ALLEGHENY COUNTY SANITARY AUTHORITY

CONTRACT NO. 1759 G, E, H, P

ENVIRONMENTAL COMPLIANCE FACILITY

ADDENDUM NO. 4

220-H-21
HYDRONIC PLAN - SECOND FLOOR

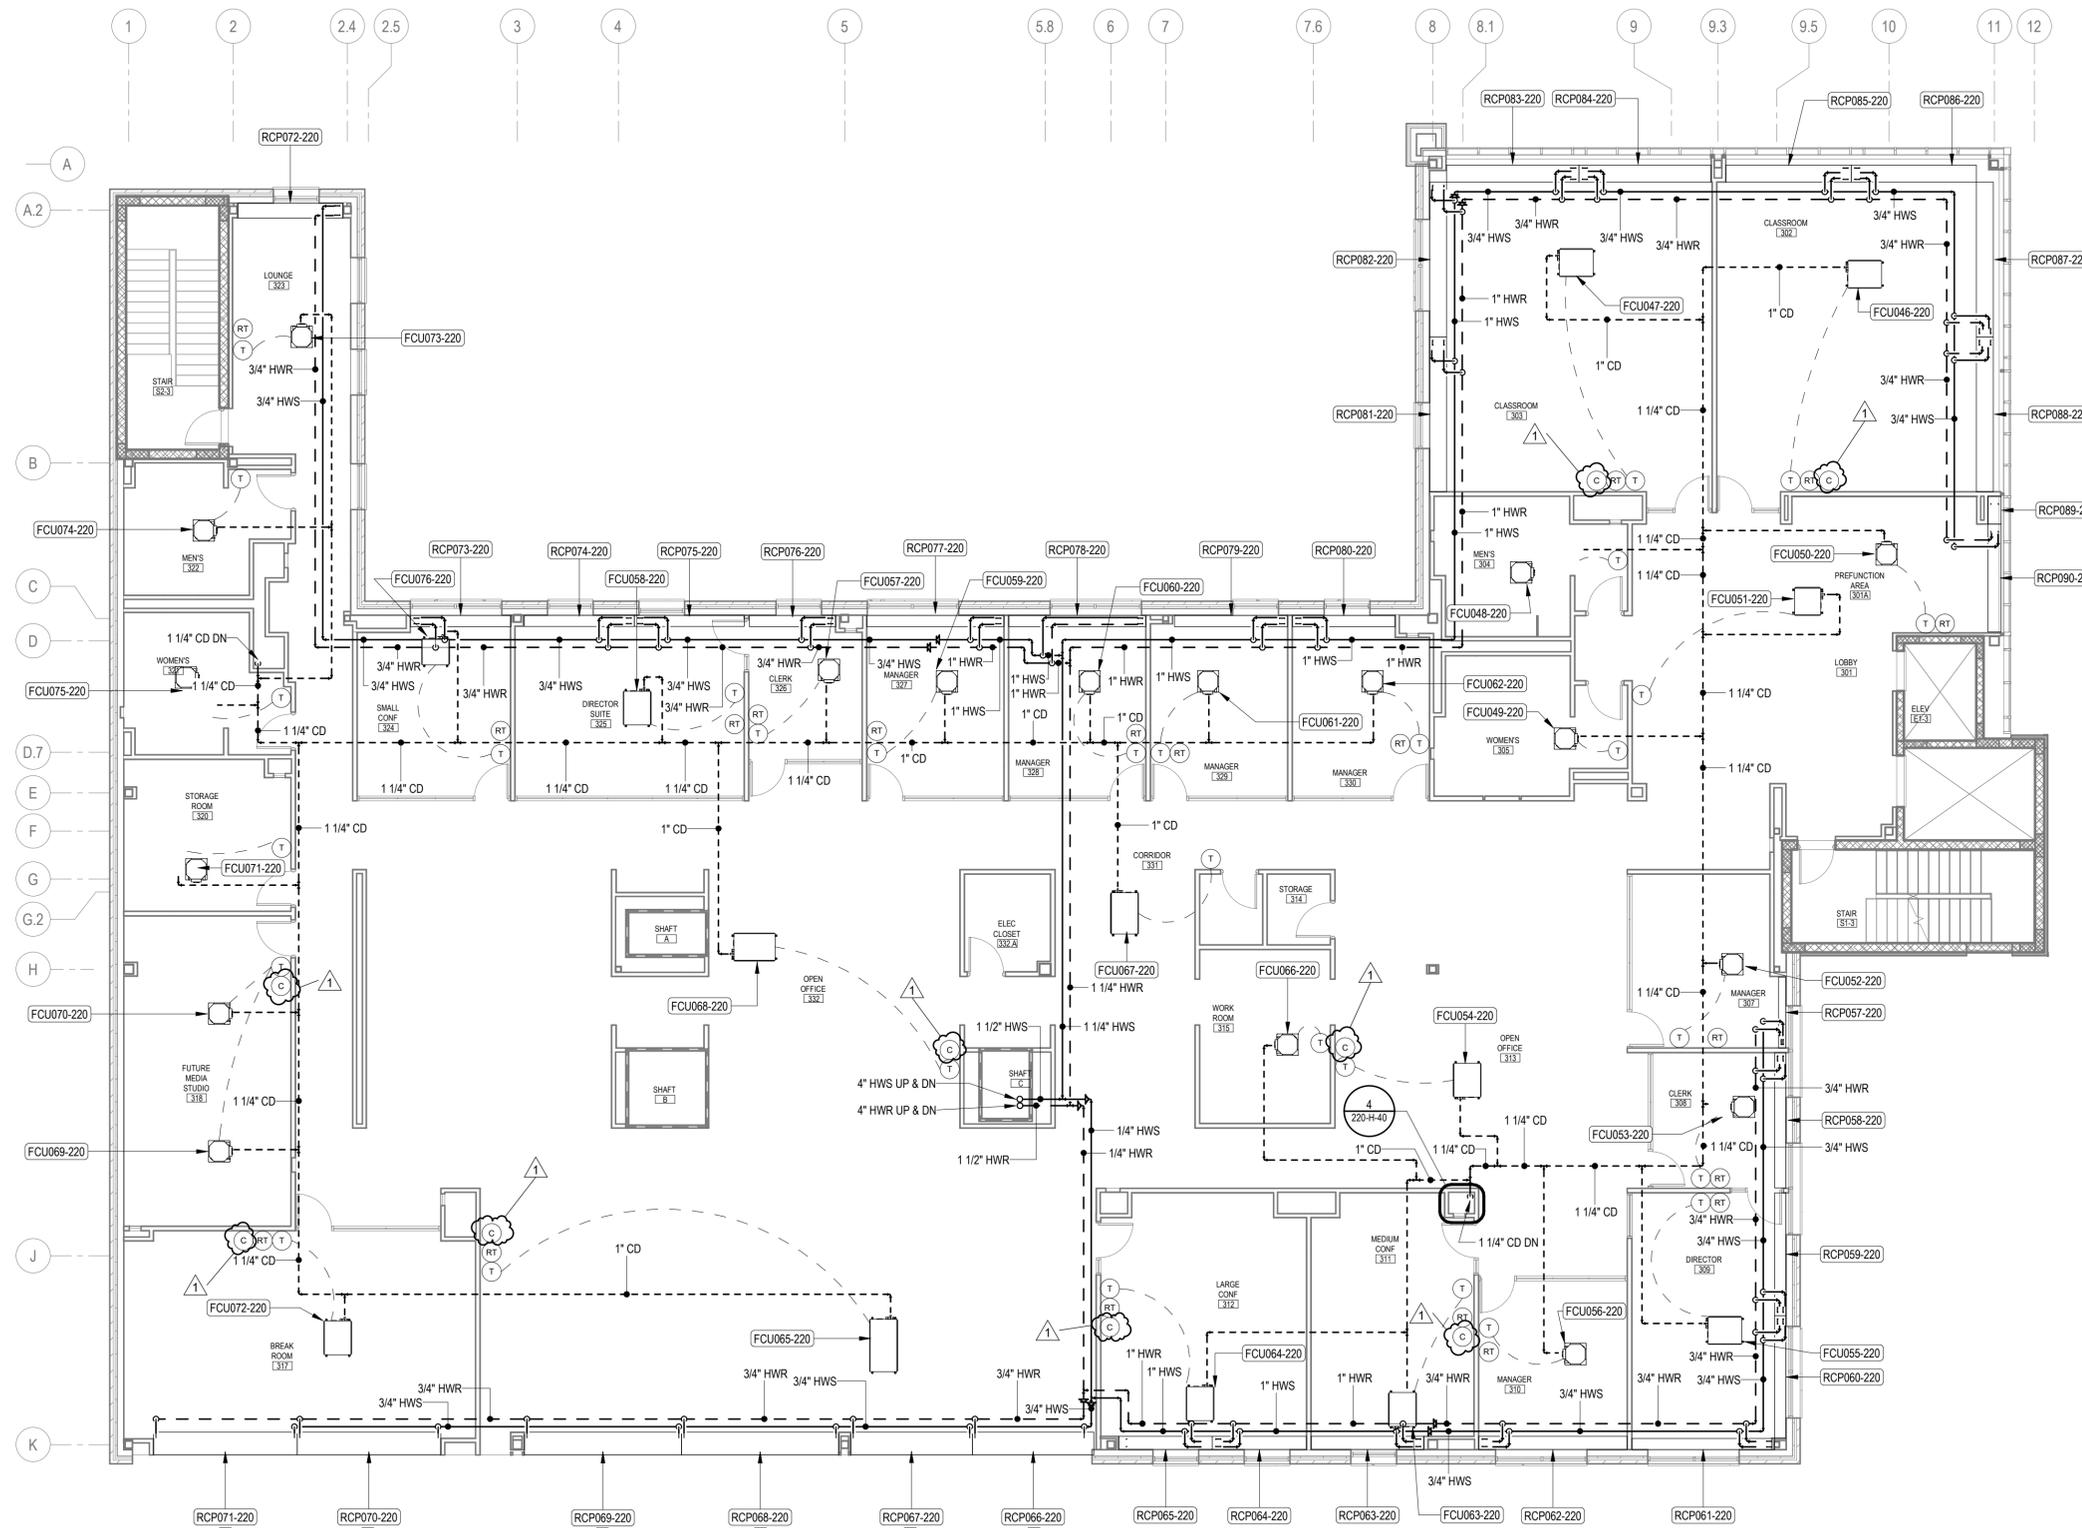
26. Drawing 220-H-21 – Hydronic Plan – Second Floor
 - a. Added CO2 sensors for demand control ventilation VAVs in various spaces
27. Drawing 220-H-22 – Hydronic Plan – Third Floor

1 HVAC HYDRONIC PLAN - THIRD FLOOR
1/8" = 1'-0"

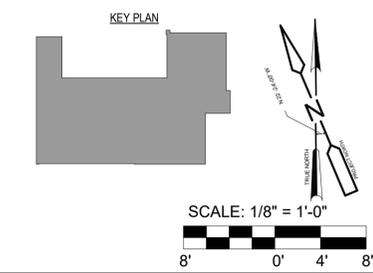
- a. Added CO2 sensors for demand control ventilation VAVs in various spaces
28. Drawing 220-HS-04 – HVAC Schedules
 - a. Revised the Diffusers, Registers, Grilles, and Exhaust Snorkel schedule to specify the snorkel
